HISTORIC AND DESIGN REVIEW COMMISSION

June 17, 2020

HDRC CASE NO: 2020-241
ADDRESS: 1119 N OLIVE ST
LEGAL DESCRIPTION: NCB 514 BLK 18 LOT 16
ZONING: R-6, H
CITY COUNCIL DIST.: 2
DISTRICT: Dignowity Hill Historic District
APPLICANT: Matt Forrester
OWNER: ROBUS PROPERTIES LLC
60-DAY REVIEW: Not applicable due to City Council Emergency Orders
CASE MANAGER: Huy Pham
REQUEST:

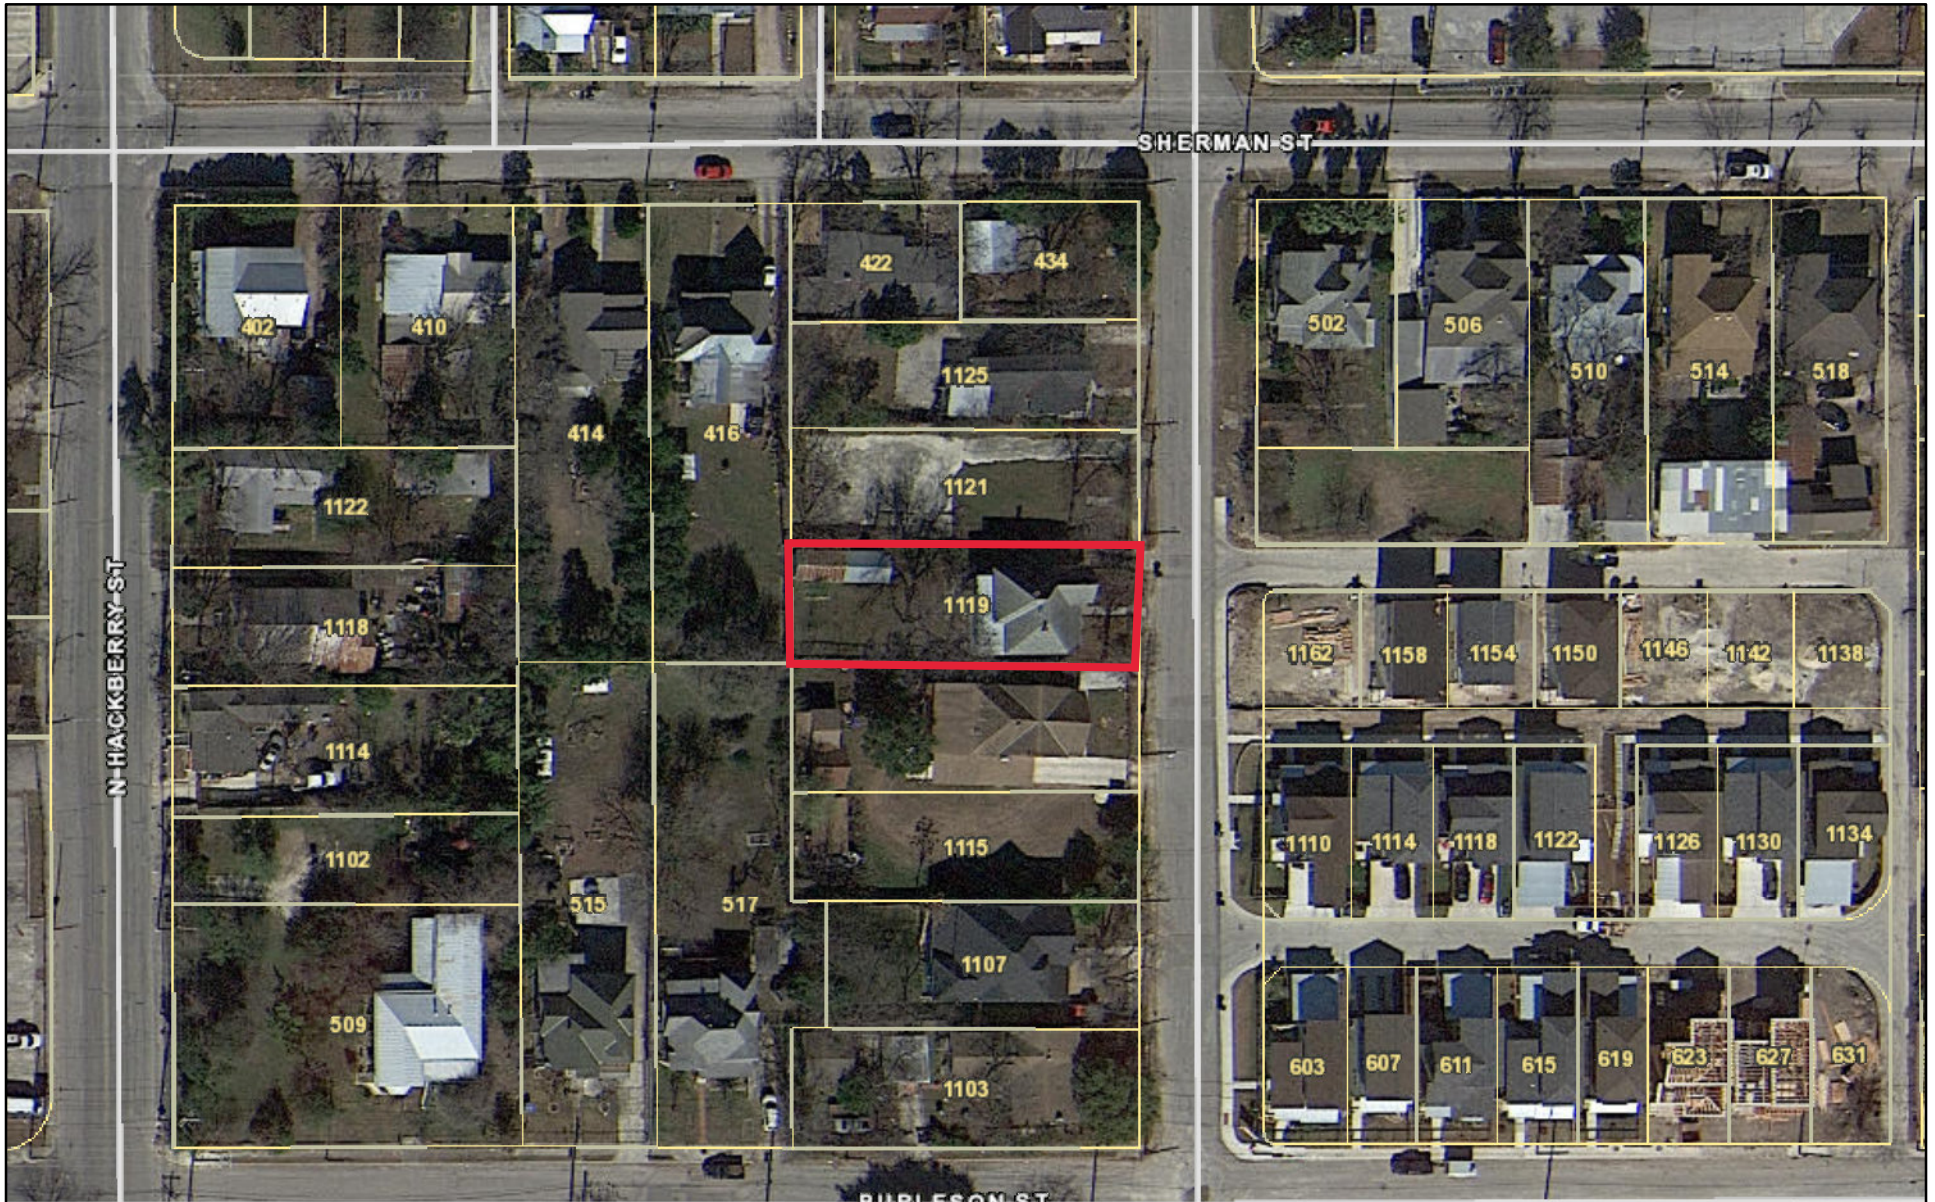
- c. PORCH RAILING – The applicant has proposed to remove the porch railing. Per the Guidelines for Exterior Maintenance and Alterations 7.B.v., applicants should reconstruct porches, balconies, and porte-cocheres based

on accurate evidence of the original, such as photographs; if no such evidence exists, the design should be based on the architectural style of the building and historic patterns. Staff finds that porch railing are not original to the structure and their removal is appropriate.

Staff recommends approval of porch railing removal based on finding c.

1. 2016 pictures after purchase of home by Robus and before repainting (also before removal of railing and replacement of steps)

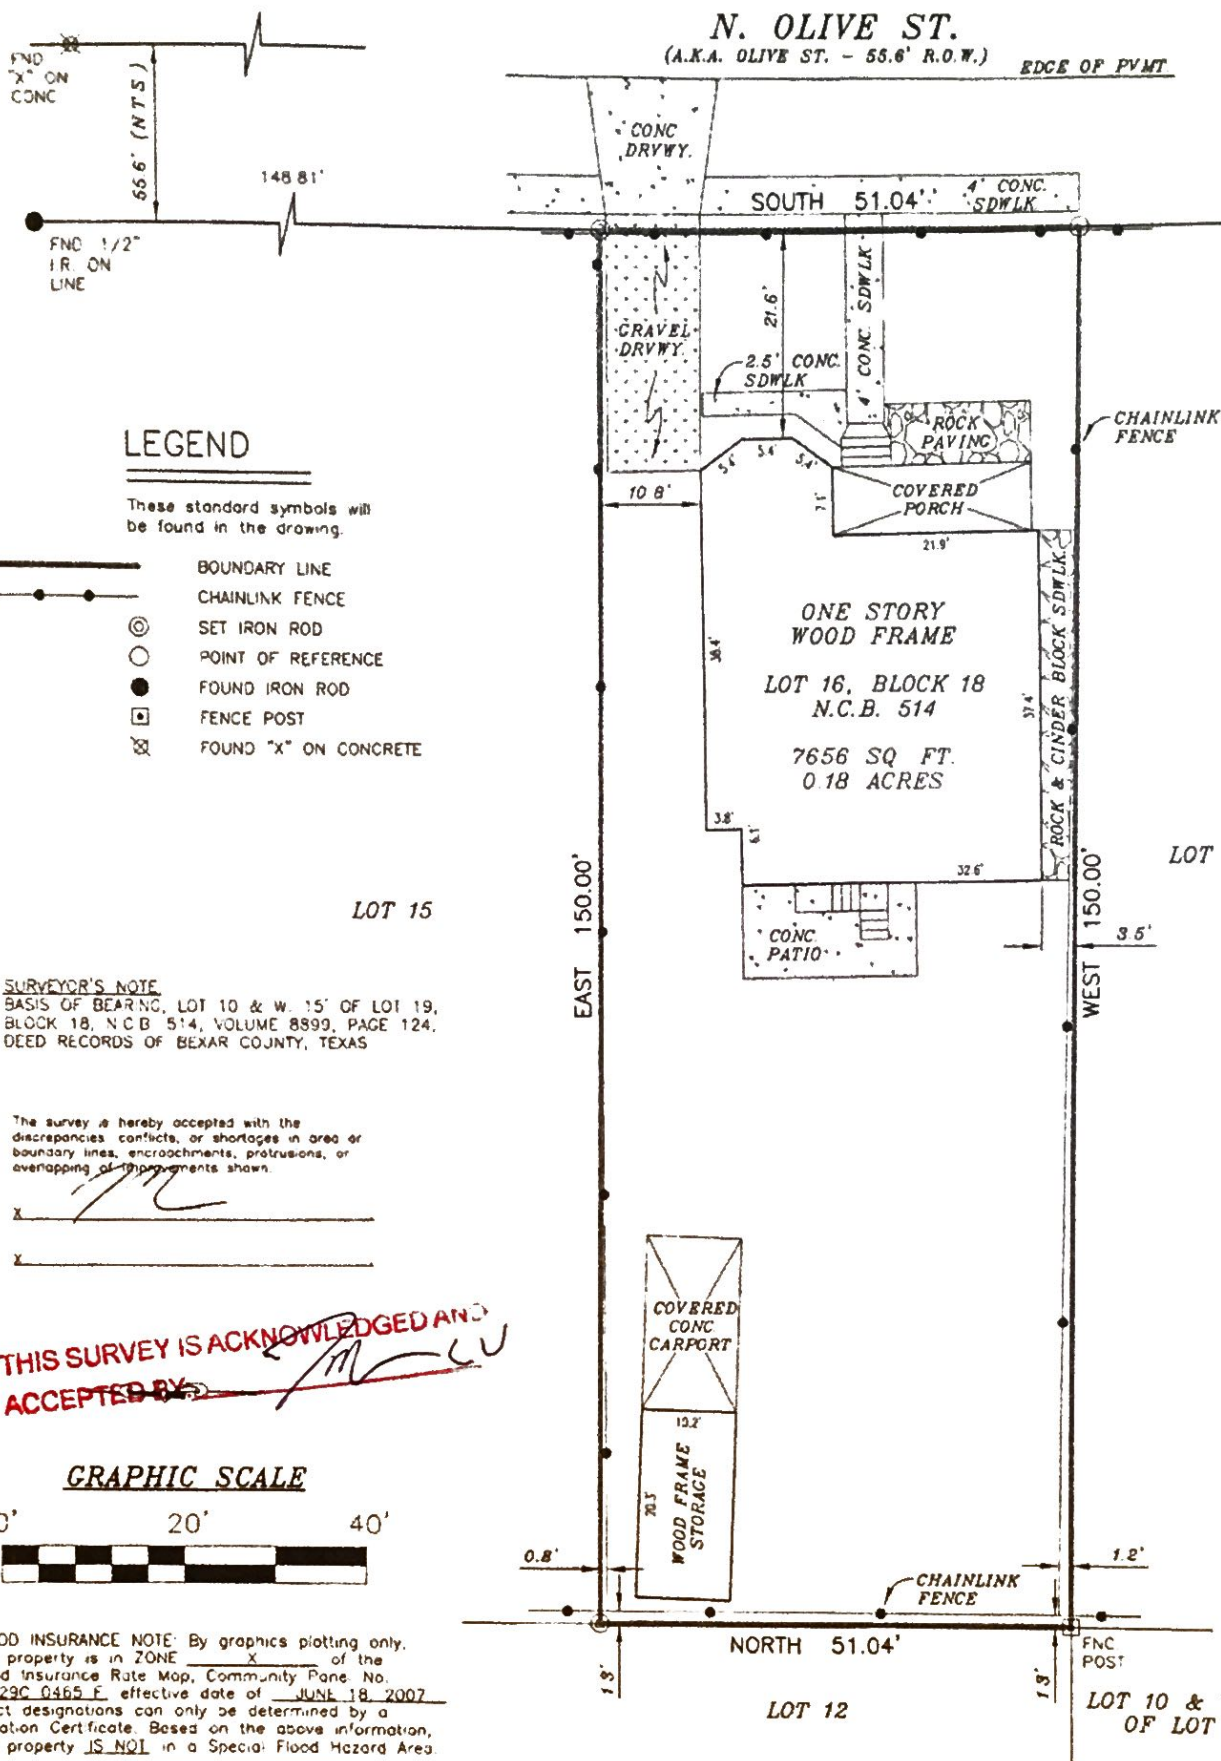
- d. PORCH STEPS – The applicant has proposed to remove the wood steps and install flagstone steps to match the existing flagstone patio in front of the porch. Per the Guidelines for Exterior Maintenance and Alterations 7.B.iii., applicants should replace in-kind porches, balconies, porte-cocheres, and related elements, such as ceilings, floors, and columns, when such features are deteriorated beyond repair. When in-kind replacement is not feasible, the design should be compatible in scale, massing, and detail while materials should match in color, texture, dimensions, and finish. Staff finds that the flagstone patio is an existing, non-conforming feature and should not be used as reference material. Staff finds that installing simple wood steps would be more appropriate and mitigate the visual impact of the inappropriate flagstone patio.

Staff does not recommend approval of the replacement the porch steps with flagstone steps based on finding d; simple wood steps should be restored after a measured drawing is approved by staff.
